**Instrument Procedures Group
April 26, 2016**

AERONAUTICAL CHARTING FORUM (ACF)
MEETING 16-01 April 26, 2016
HOST: Air Line Pilots Association (ALPA)
535 Herndon Parkway
Herndon, VA 20192

INSTRUMENT PROCEDURES GROUP (IPG) AGENDA

FAA Control # ACF-CG RD 16-01-304**Subject:** Depicting non-standard maximum holding speeds**Background/Discussion:**

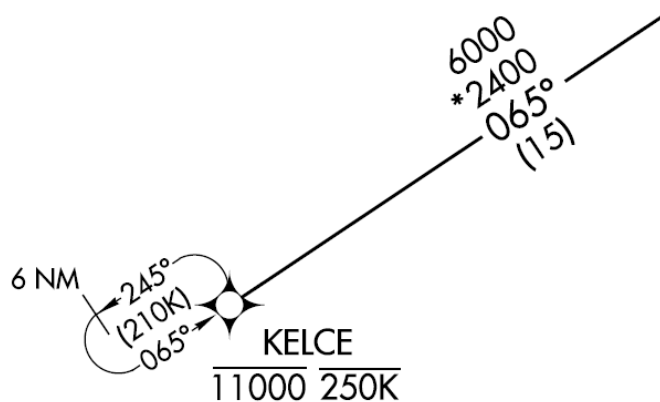
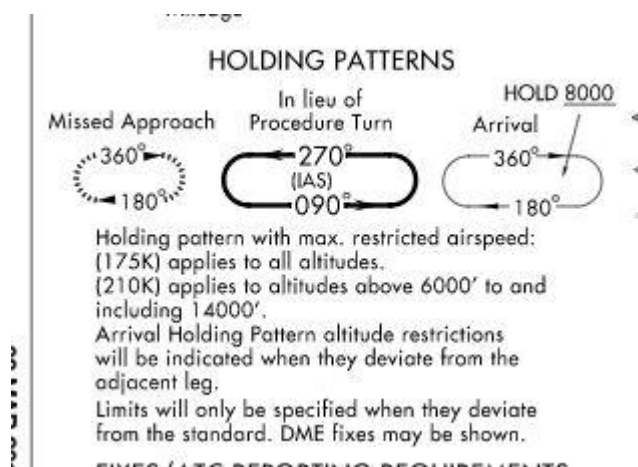
Aeronav charts depict maximum holding speeds when nonstandard, but they do not include the effective altitudes. An example of this is on the DUCXS THREE Arrival in KRIC.

The speed of 210 only applies for altitudes of 6,001' to 14,000'. However if you were holding at 6,000' or less, the maximum hold speed of 200 KIAS would apply. Labeling this (210K) could induce people to fly the hold at 6,000' at 210 KIAS.

While this is covered in the glossary, it can lead to confusion on what altitudes the speed restriction applies to.

Add affected altitudes to the non-standard holding speeds to reduce confusion.
